**HERSCHEL  
PLANCK**

**1553 Bus Protocols**

**Technical note**

**Ref:** SPIRE-RAL-PRJ-  
**Issue:** 1  
**Date:** 3/10/01  
**Page:** 8

**Figure 4-1: Bus message transmission in Burst Mode (PS-ICD)**

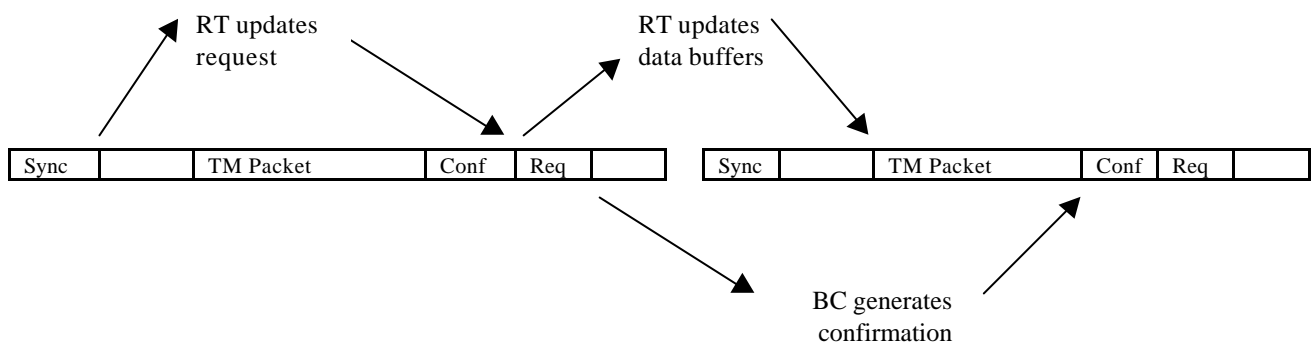
In burst mode the handshake is compressed in time A,B,C & D occur first to establish burst mode. E & F repeat during each subsequent subframe while burst mode is maintained. Referring to the figure below we see that both BC and RT have to write to the ACE chip's active buffers (those used during the currently running subframe). This presents a more difficult problem than the 'normal' case of section 4.1.1, since more exact timing is required and a memory clash must be avoided. It is preferred to use double-buffering as discussed above.

Figure 4-1 illustrates PS-ICD requirement 4700-TFL-T, specifying burst mode transfers. An RT recognises a subframe containing its packet transfer from the subframe sync message. It updates its TMReq at this point. It may update the TM Packet buffers at the same time; a maximum of 2mS is allowed from start of subframe. Alternatively, if this suits the RT software, it may prepare a new packet after the confirmation in the previous subframe as illustrated in the figure.

The BC, on reading the TMReq message, generates a TM confirmation message which will be run in the next subframe. At run-time there will not be enough time to evaluate the packet transfer for errors before the confirmation message is actually transferred. Hence the TM Confirmation merely indicates the expected transfer.

Since the bus transactions are regular and deterministic, the RT already knows that if a packet is ready it will be transferred in that subframe where the sync message contains its RT number. Thus the TM confirmation is redundant in a practical system.

As mentioned in the previous section it is likely that in a practically constructed system, the TM Confirmation message will not be as useful as implied in the PS-ICD, at least in burst mode. The message is redundant if the RT uses the information in the subframe sync, and is fast enough to update its buffers in 2mS. Hence we could propose to delete it altogether.

**Figure 4-2: Modified Packet transfer protocol**

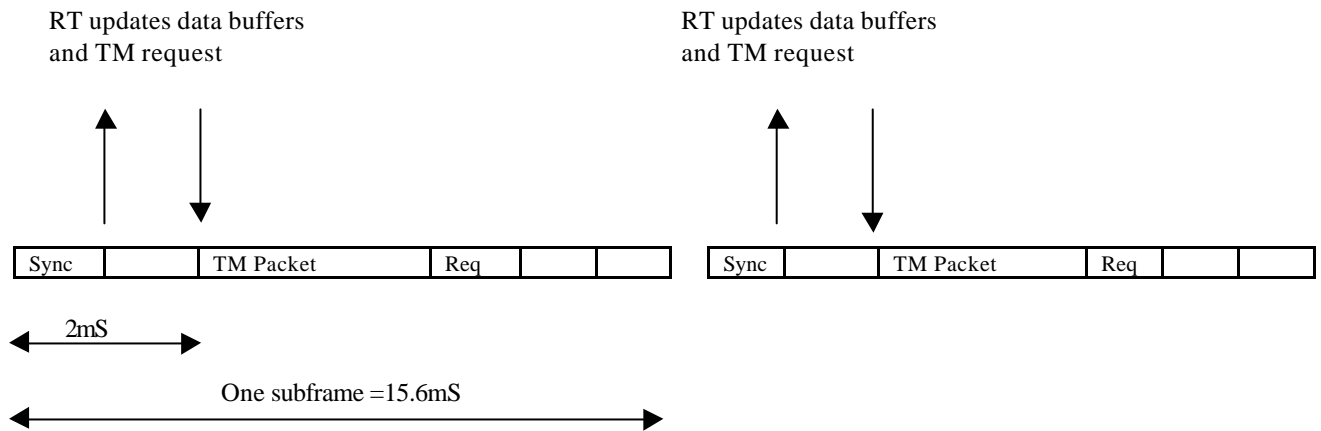
The modified 'handshake' uses the TM Request as defined in the PS-ICD. It is polled in the same subframe as its associated Packet TM and the BC uses the information to build a packet from the data in subaddresses 11-26. The BC will always transfer all of these subaddresses from the RT. This system has the advantage that all of the messages related to one packet are in one subframe, making it much easier to construct a complete bus polling sequence for the whole spacecraft. There is also consistency between normal and burst mode requirements.
